Applicati n N .	Applicant(s)
Notice of Allowability	10/777,445	NAKAYAMA, AKINORI ()//
Notice of Allowability	Examiner	Art Unit
·	George Nguyen	3723
The MAILING DATE of this communication appears n the cover sheet with the correspondence address All claims being allowable, PROSECUTION ON THE MERITS IS (OR REMAINS) CLOSED in this application. If not included herewith (or previously mailed), a Notice of Allowance (PTOL-85) or other appropriate communication will be mailed in due course. THIS NOTICE OF ALLOWABILITY IS NOT A GRANT OF PATENT RIGHTS. This application is subject to withdrawal from issue at the initiative of the Office or upon petition by the applicant. See 37 CFR 1.313 and MPEP 1308.

## **EXAMINER'S AMENDMENT**

Figure 4

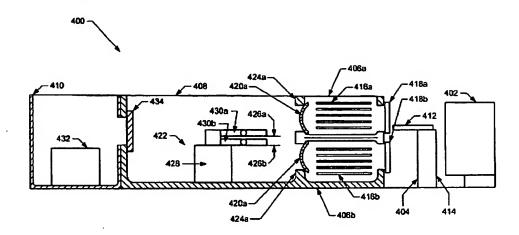
With reference to Figure 4, col. 7, lines 13-27, Tabrizi et al.'6,647,665 discloses a dual lock system to allow almost continuous processing without significant down time for providing new workpieces from the atmospheric clean room to the vacuum processing environment. Please note that it appears that linear door 418a either slide horizontally or slide upwardly to allow access to the processing chamber.
